Item ID: D350-607-541 Accept *N900040100* Setup Start *NS1*
 Revision ID: Stop *NS2*
 Item Name: Quick Release Heli-Utility-Basket™ Long, HD Lid, Spacepod™/Squirrel Cheek Comp.
 Start Date: 2/2/2016 Start Qty: 1.00 *1* Cust Item ID:
 Required Date: 2/12/2016 Req'd Qty: 1.00 *1* Customer:

DART SERVICE INSTRUCTION

**TO AMEND INSTALLATION INSTRUCTIONS D350-607-3 Rev.D,
INSTALLATION INSTRUCTIONS D350-607-4 Rev. C AND
INSTRUCTIONS FOR CONTINUED AIRWORTHINESS ICA-D350-607 REV. 6**
REF TCCA STC: SH94-14
REF FAA STC: SR00213NY
REF EASA STC: EASA.10016996
REF BRAZILIAN STC: 2007S03-03/-04/-05/-06

A	NEW ISSUE	AJS	14.05.16
REV.	DESCRIPTION	BY	DATE
DESIGN	AJS	DART AEROSPACE LTD	
DRAWN	AJS	HAWKESBURY, ONTARIO, CANADA	
CHECKED		DRAWING NO.	REV. A
MFG. APPR.	N/A	DSI 9699	SHEET 1 OF 2
APPROVED		TITLE	SCALE
DE APPR.		LUG REPLACEMENT	NTS
DATE	14.05.16	COPYRIGHT © 2014 BY DART AEROSPACE LTD THIS DOCUMENT IS PRIVATE AND CONFIDENTIAL AND IS SUPPLIED ON THE EXPRESS CONDITION THAT IT IS NOT TO BE USED FOR ANY PURPOSE OR COPIED OR COMMUNICATED TO ANY OTHER PERSON WITHOUT WRITTEN PERMISSION FROM DART AEROSPACE LTD.

FIGURE 1: INSTALLATION OF D4775-041 FWD STRUT

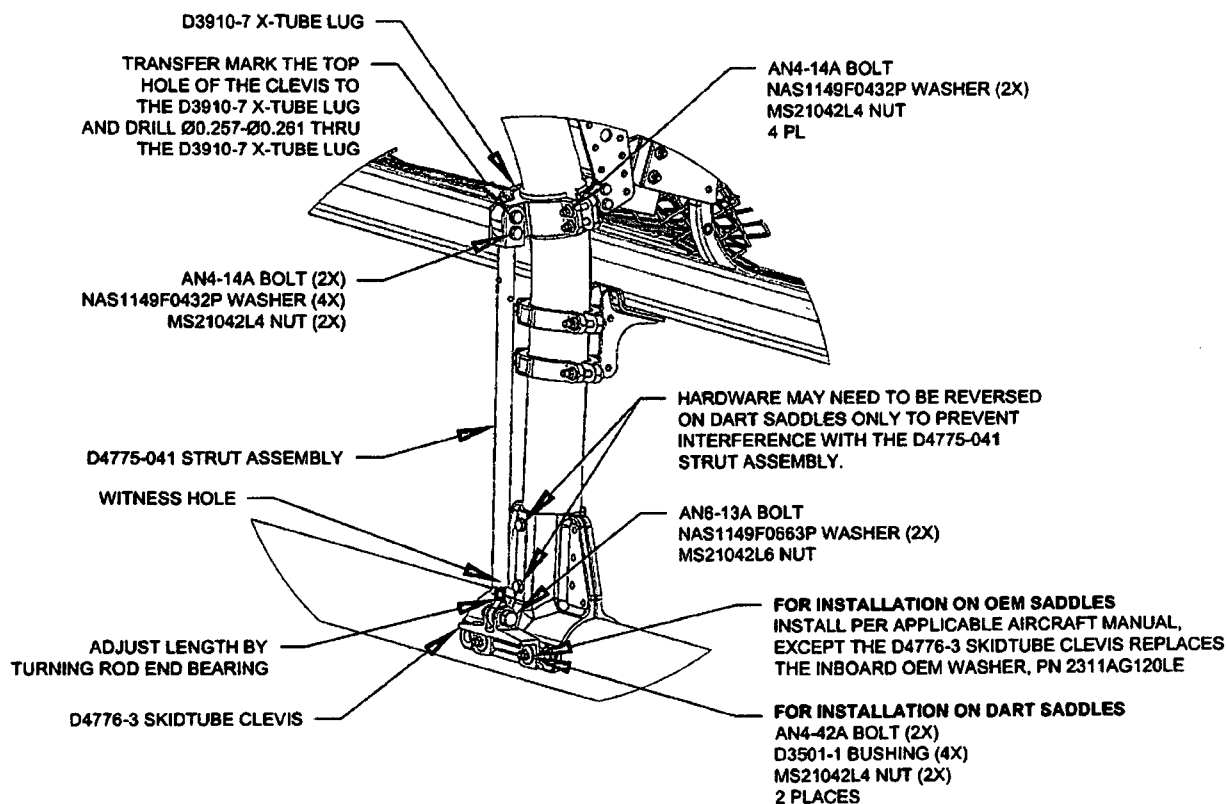
- 3.1 Substitute the Forward Lower D3910-5 X-Tube Lug with the D3910-7 X-Tube Lug as shown in Figure 1.
- 3.2 Install the forward D4775-041 Strut Assembly. Transfer mark from the upper hole on the clevis of the D4775-041 Strut Assembly to the D3910-7 X-tube Lug and drill thru the lug $\varnothing 0.257$ - $\varnothing 0.261$ as shown in Figure 1. Touch up chemical conversion coating per MIL-DTL-5541. Check the witness holes located at the bottom end of the D4775-041 Strut Assemblies to ensure that the thread from the rod end extends past the witness hole.
Torque MS21042L4/-4 nuts to 50-70 in-lbs (5.7-7.9 N-m). Torque MS21042L6/-6 nuts to 160-190 in-lbs (18.1-21.5 N-m).
- 3.3 Complete the installation in accordance with Installation Instructions D350-607-3 Rev. D or D350-607-4 Rev. C.
